Re: Plan Change 27 Additional Information

Proposed Outline Development Plan
South West Rangiora
Townsend Road Residential 2 Zone
for MA Clarke and Willaims McKenzie Trustees Limited

Re: Plan Change 27: Flood Displacement Modelling

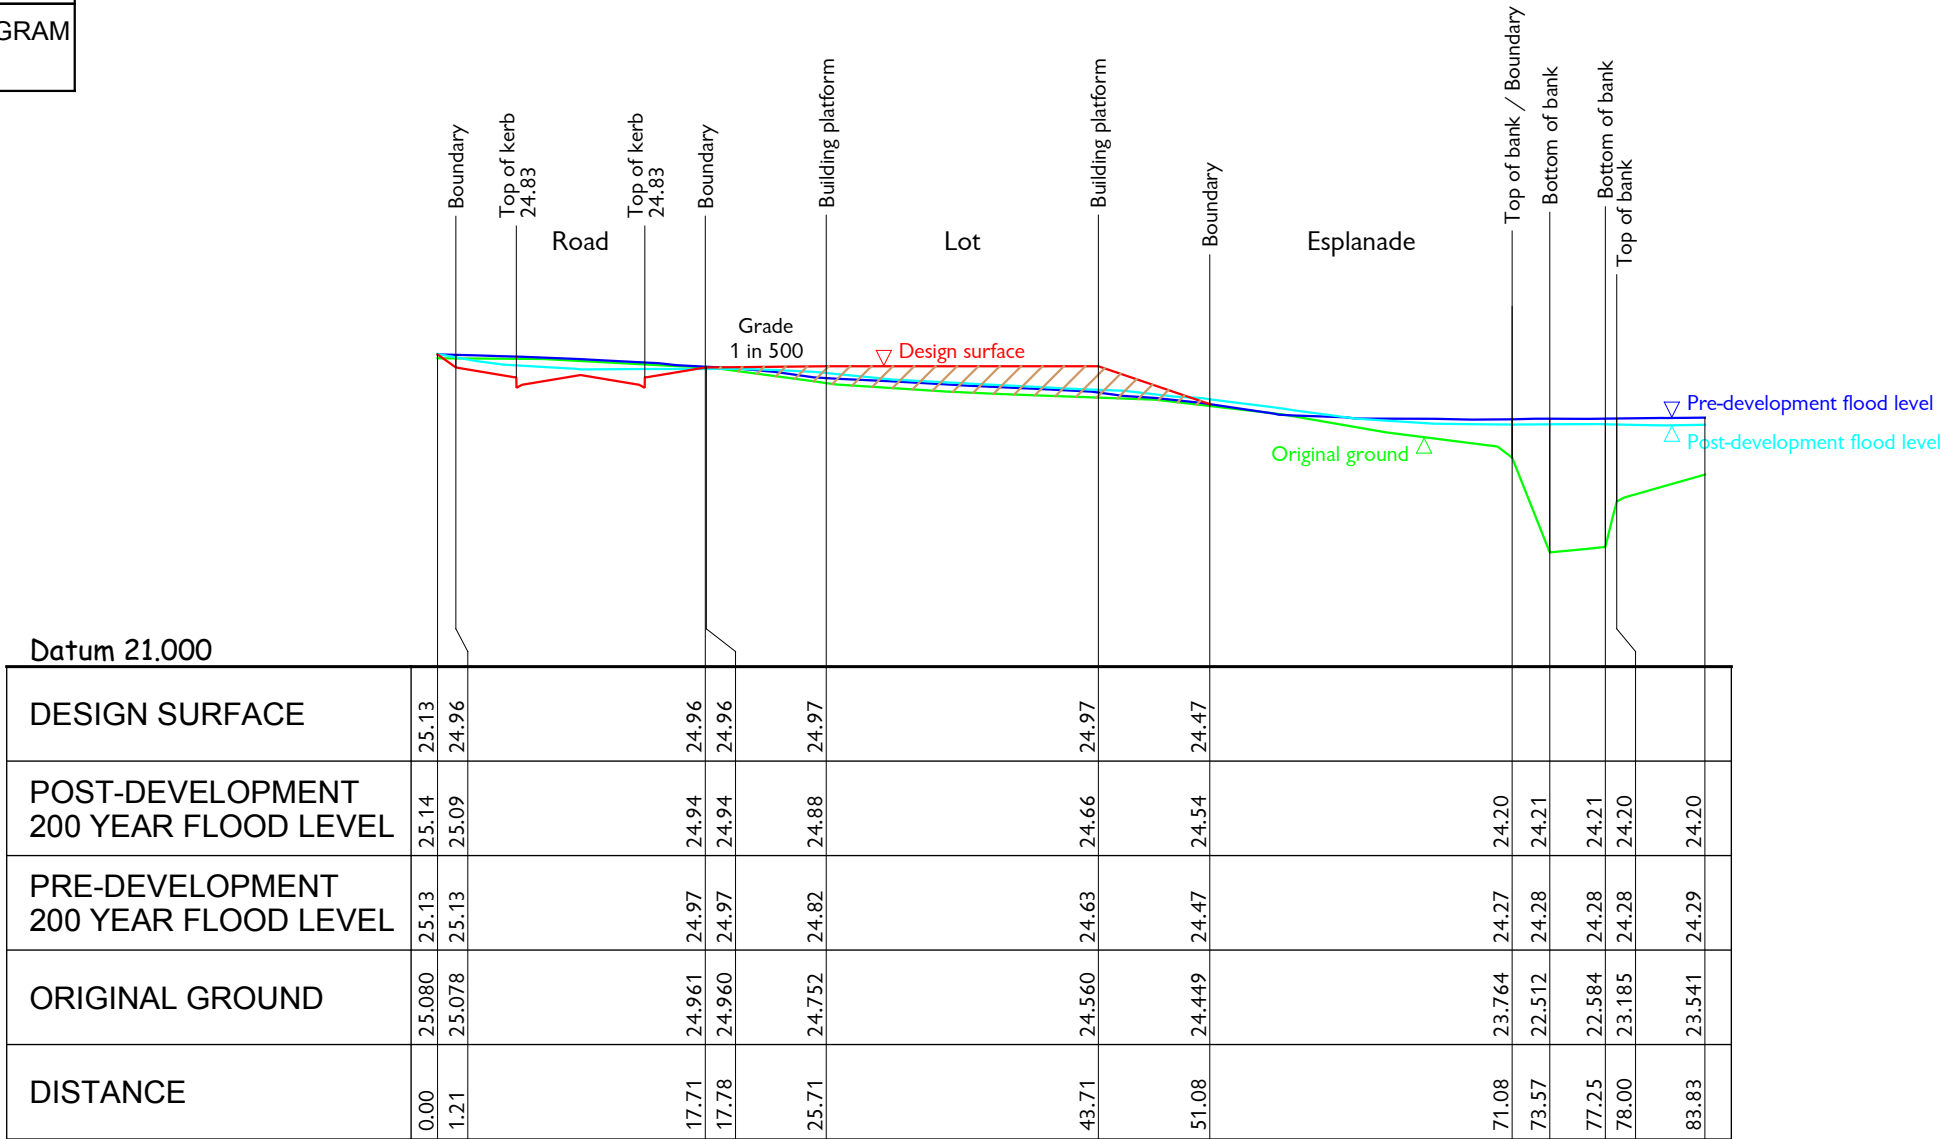
We have made a number of minor corrections to the ODP plan, to reflect the width of pedestrian and cycle links being changed to 10m. As a result of the changes to the width of the pedestrian and cycle links we have amended the roading layout internal to the site to enable future allotments to meet the District Plan provisions. The amended layout is a minor correction in location and is not significantly different to the layout notified and no changes have been made to the connection points to South Belt. Based on the amendments to the ODP more certainty has been made and the internal roads are no longer shown as indicative on the ODP.

It is proposed that the ODP as notified be removed and replaced with the amended ODP attached and that the proposed amendments to the Waimakariri District Plan (the rules) also be replaced with those attached in this letter. No other changes are proposed to the Plan Change Request.

TYPICAL CROSS-SECTION THROUGH LOT ADJACENT TO ESPLANDE
PROPOSED SOUTHBELT SUBDIVISION, RANGIORA

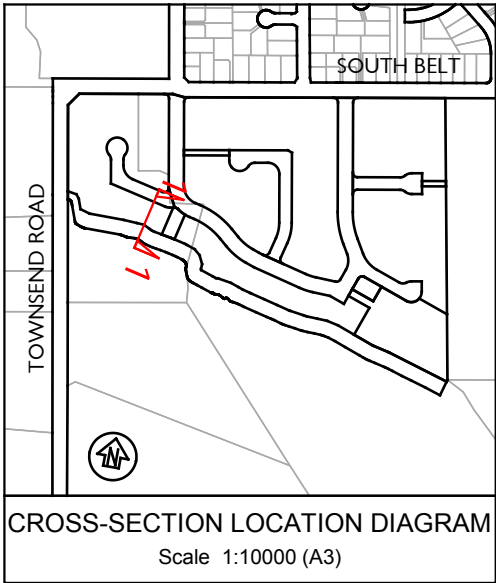
As the filling is less than previously anticipated the effects on the sites between the southern road and the esplanade are insignificant and no additional assessment is considered necessary with regards to amenity, stormwater and flood management. We have provided a cross-section (see attached), at the location where the highest fill will be required, to show the typical level and amenity between the esplanade and the southern road. Please note that no retaining walls are anticipated.

MAXIMUM FLOOD DEPTHS DURING 200 YEAR RETURN PERIOD LOCAL FLOOD MODEL - PRE DEVELOPMENT
PROPOSED SOUTHBELT SUBDIVISION, RANGIORA

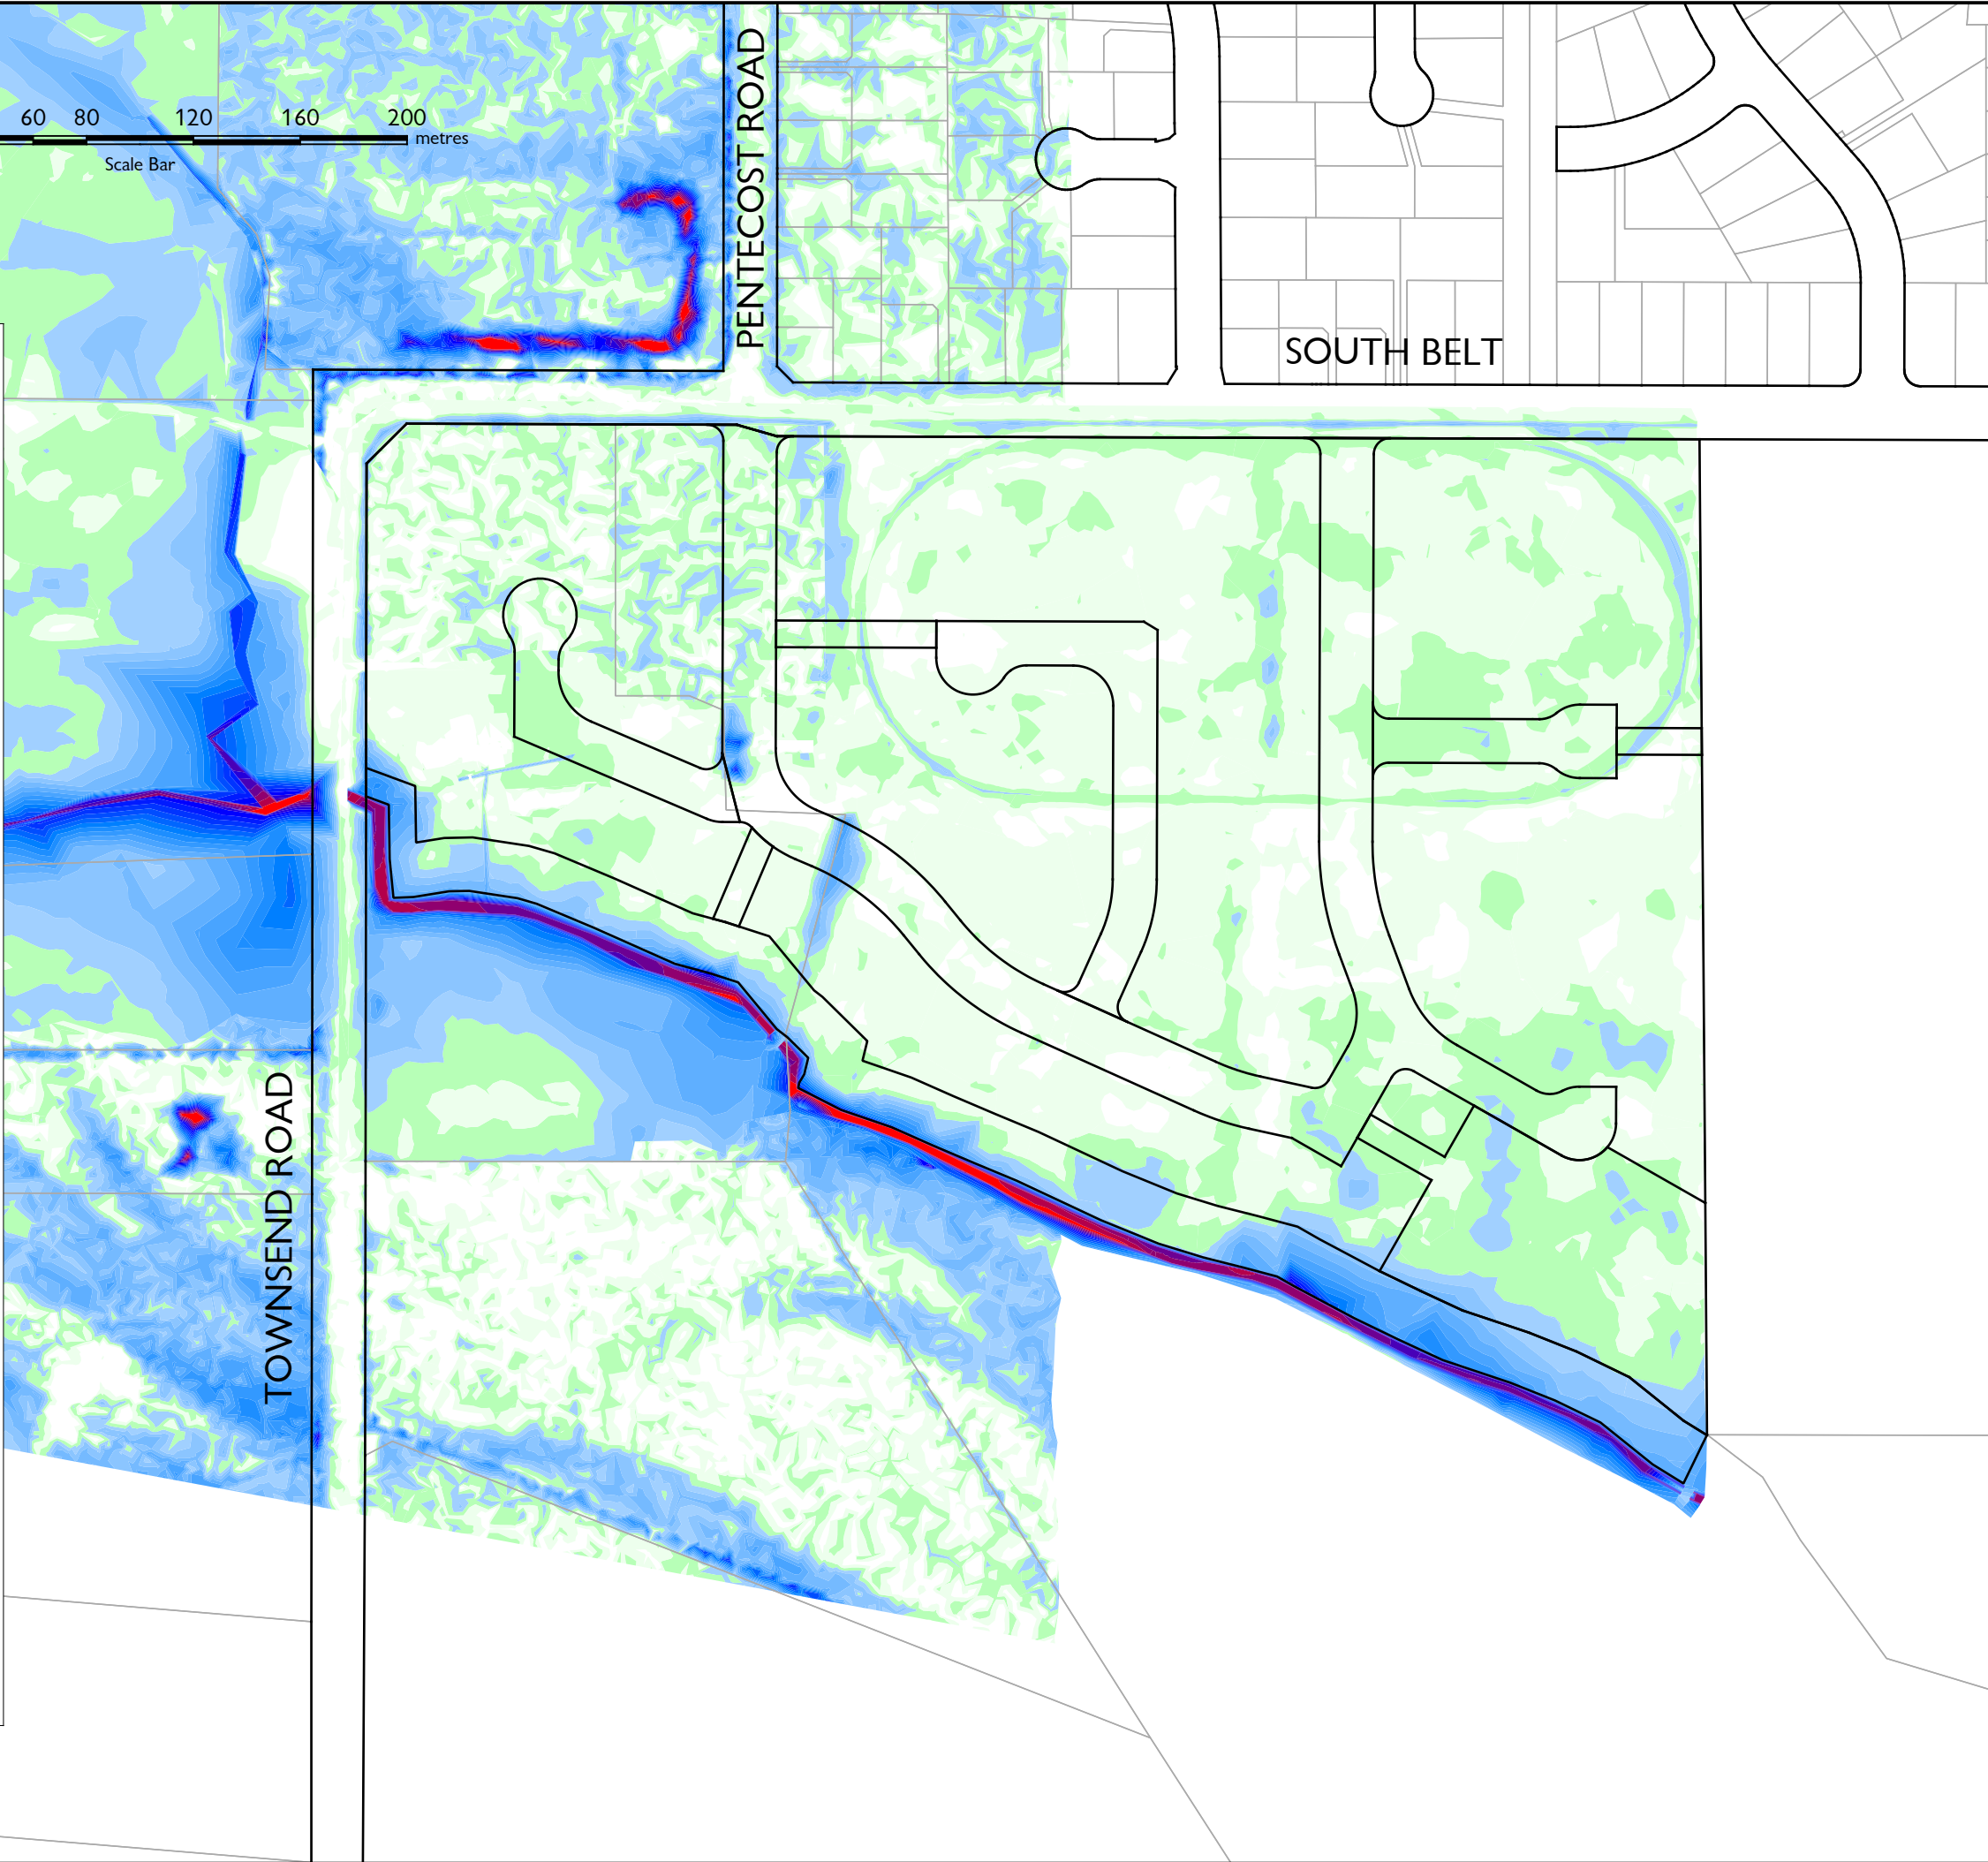
Drawing 196916 M4 Sheet 1 is colour coded to show the depth of the 200 year flood above existing ground levels. The flood modelling indicates that filling of between 0 and 200mm above existing ground level will be required over the majority of the Plan Change 27 site (The Site) to match the 200 year flood levels.

MAXIMUM FLOOD DEPTHS DURING 200 YEAR RETURN PERIOD LOCAL FLOOD MODEL - POST DEVELOPMENT

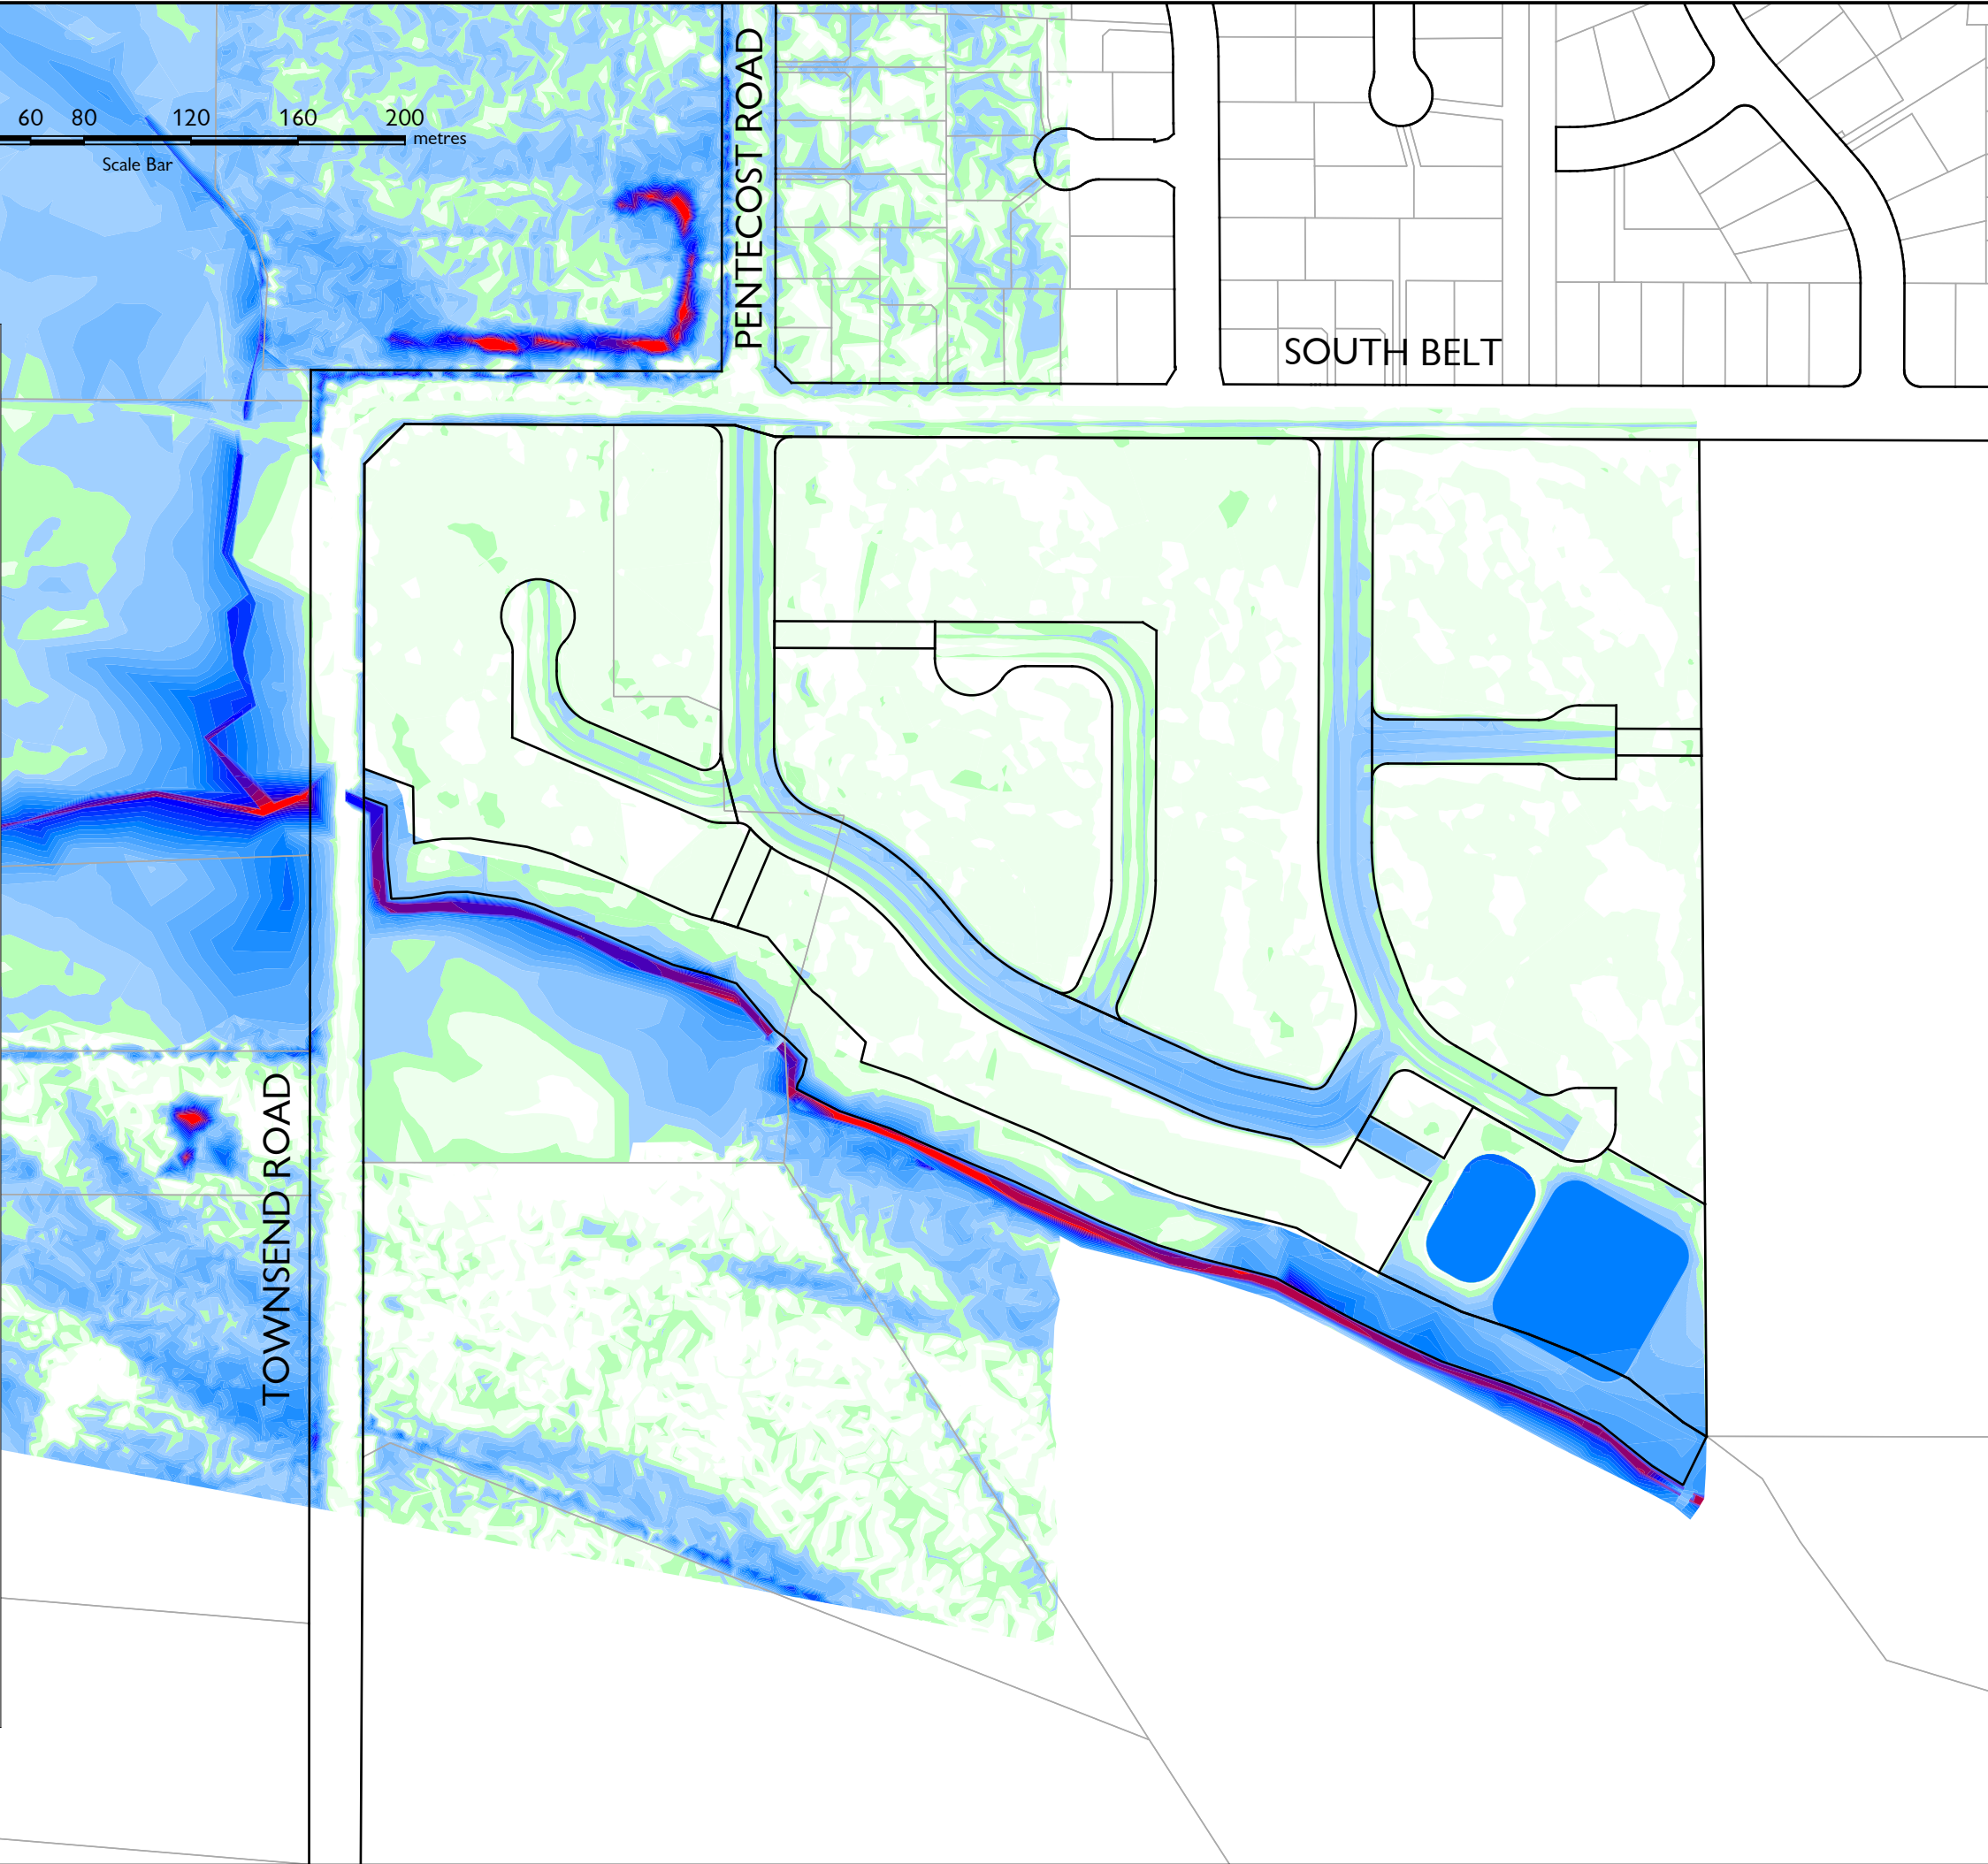
As we are at the plan change stage, a detailed drainage design has not been produced. The proposed ground levels on drawings 196916 M4 Sheets 2 & 3 are based on filling the residential lots to the 200 year flooding level as a minimum and cutting out the roads to direct secondary flow to the stormwater management area and the South Brook, and away from neighbouring properties.

Drawing 196916 M4 Sheet 2 is colour coded to show the depth of the 200 year flood above the proposed ground levels. The flood modelling indicates that 200 year flood levels will be between 0 and 100mm above the filled ground levels over the majority of the residential areas of The Site. This indicates that the 200 year flood would not enter any dwellings given the proposed 300mm freeboard. This approach was agreed with Council staff.
